BAR CASE # 2013-00066 &
2013-00067

City Council
April 12, 2014

ISSUE: Appeal of a decision of the Board of Architectural Review, Old & Historic Alexandria District, approving a Permit to Demolish/Capsulate and Certificate of Appropriateness for new addition and alterations

LOCATION: 207 Prince Street

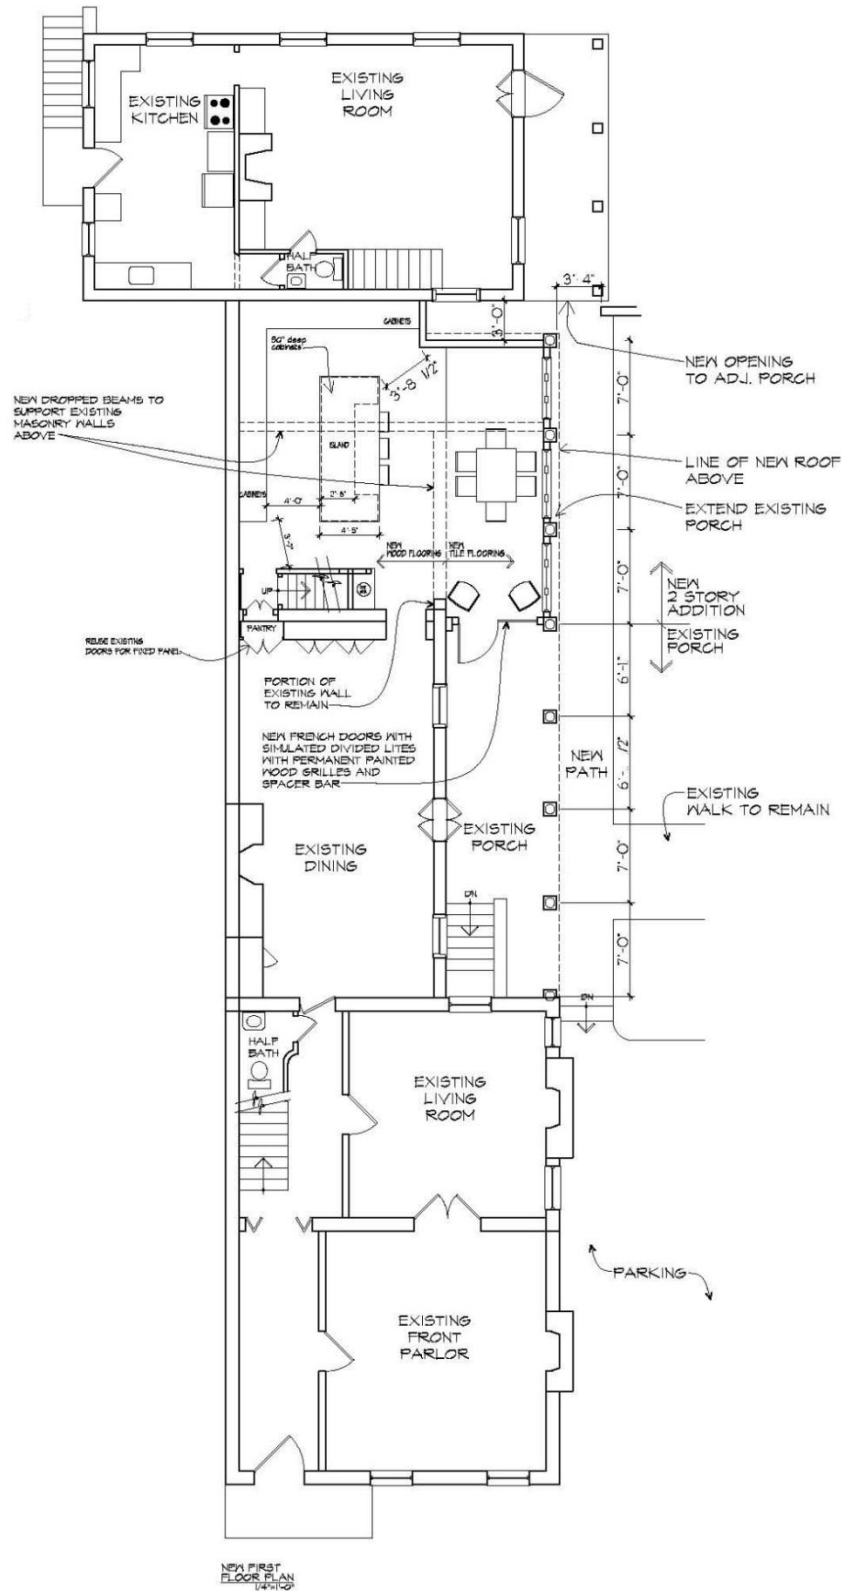
Figure 8: Initial proposal for east elevation, as submitted by applicant in March 2013. Note that the proposed replication and northern extension of the mid-20th century, two story open porch obscures the original kitchen ell of the house. In this scheme, the modern porch becomes the dominant design feature. The north end of the porch also ends awkwardly in the middle of the hyphen windows.

Staff expressed concern with the initial design, as the proposed addition significantly diminished legibility of the northern portion of the ell, where the existing kitchen is located, as a discreet building feature. The proposed second-story porch matched exactly the existing porch, now historic in its own right, and then obscured the building masses that comprise the historic ell. This made it difficult to understand the growth and development of the original dwelling and is contrary to the Secretary of the Interior's Standards for Rehabilitation, particularly #9 and #10 which state that:

Figure 10: Alternate design suggested by BAR Staff

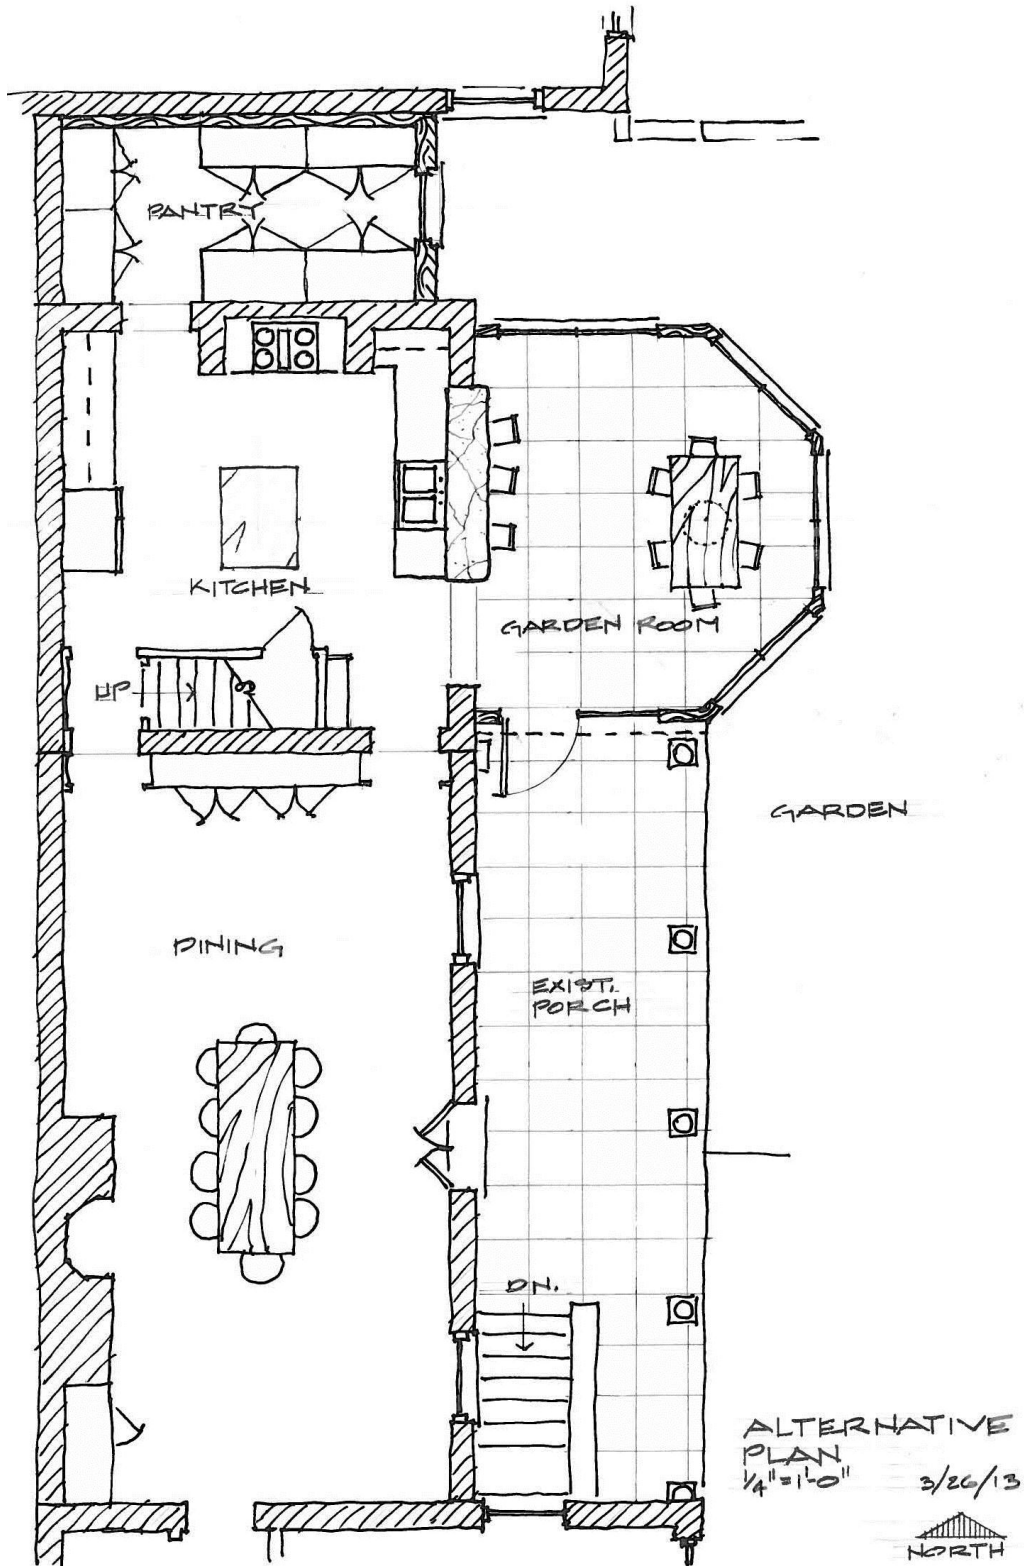
Therefore, Staff recommended to the applicant an addition much smaller in height and floor area that does not try to match the original building or the 1930's Colonial Revival alterations, but stands on its own. A delicate single story kitchen projecting slightly beyond the existing porch, much like a Colonial Revival conservatory, would read as a garden feature rather than part of the house and take up very little useable open space in the garden. Like the plan submitted by the applicant, a one-story addition would still provide generous kitchen work space, substantial pantry storage and circulation for entertaining and daily use by the family. The masonry opening to the garden room could be a large segmental masonry arch with a wood vaulted ceiling in the garden room/breakfast area to allow light back into the kitchen. A similar design was recently approved by the BAR at 504 Prince Street. The alternative designs suggested by Staff are illustrated in *figure 10* and *figure 11*.

Figure 12: Revised proposal by applicant and current application submission

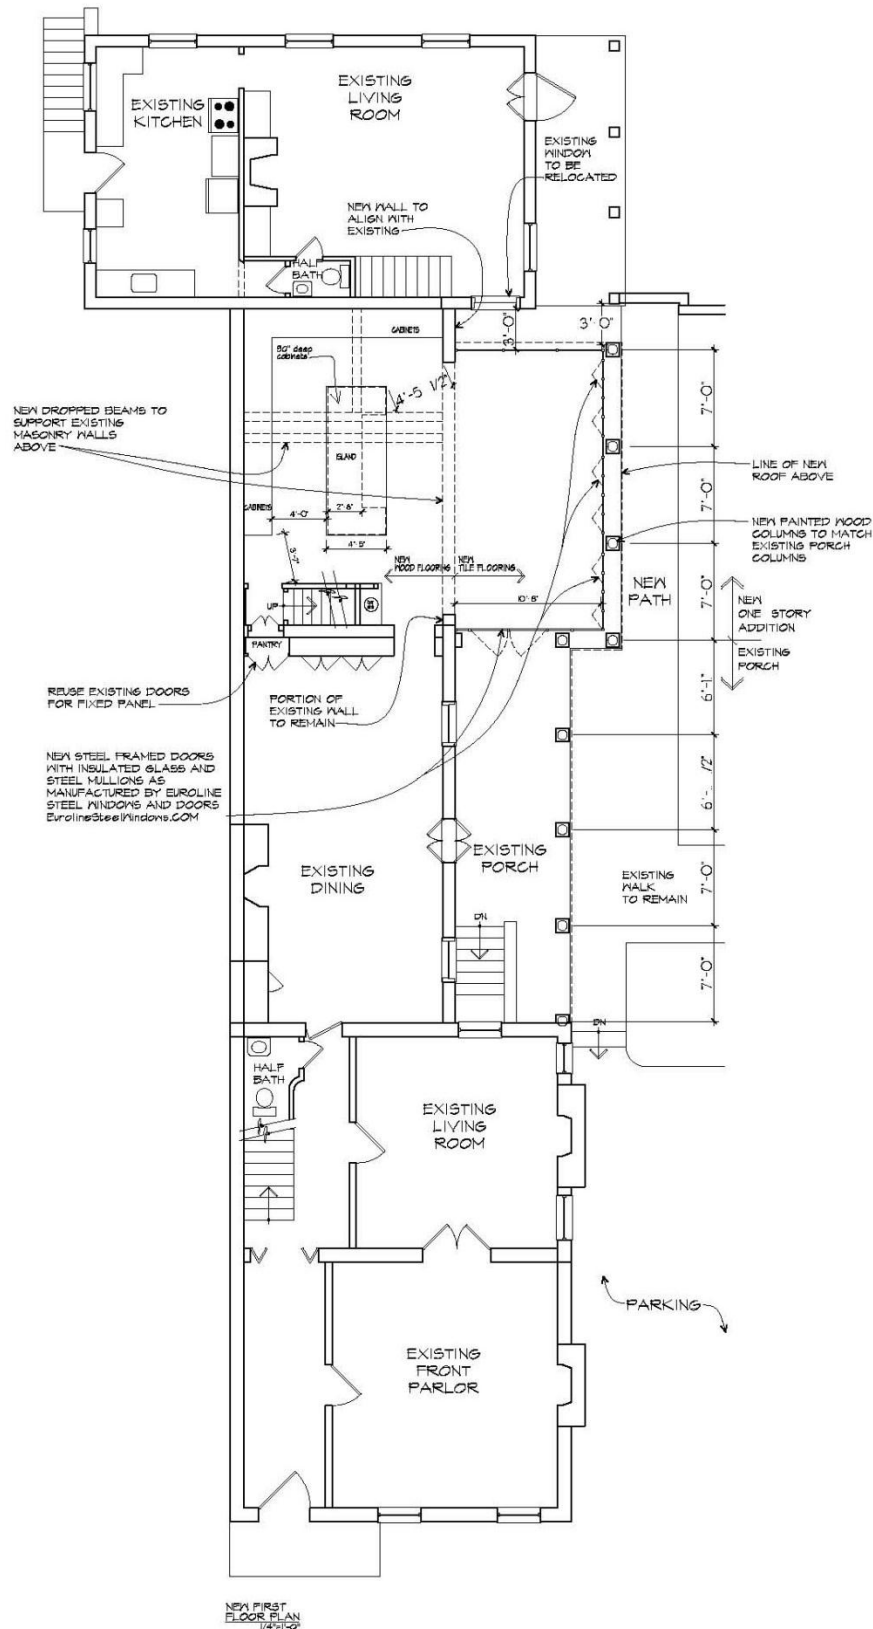
Although Staff would prefer that a greater portion of the north and east masonry walls at the first floor be preserved and incorporated into the new plan, Staff acknowledges that these masonry walls have been altered many times in the past and has no objection to the exterior design of the proposed kitchen addition. As historic maps and photographs show, there have been several alterations to the east elevation over the years. The visual mass of the proposed addition has been significantly scaled back since the initial application and its impact on the existing east elevation minimized by the elimination of the second story covered porch.

The proposed enclosed porch design parti is often used on historic buildings to avoid competing with the primary building mass. The size and spacing of the new columns recall the existing porch without replicating the segmental arch detail of that Colonial Revival era design. The modern steel and glass doors on the proposed addition float behind the columns and clearly distinguish this infill as a modern addition. The applicant has alluded to floor material changes and ceiling design that will visually interpret the location of the original masonry walls and it is Staff's recommendation that this be made a condition of the Certificate of Appropriateness. Furthermore, Staff recommends that an approval for a Permit to Demolish include the condition that the historic floor joists of the first and second story remain in place. These alterations, if approved, will preserve the historic integrity and understanding of the evolution of this important house while allowing its inhabitants a contemporary kitchen and living space.
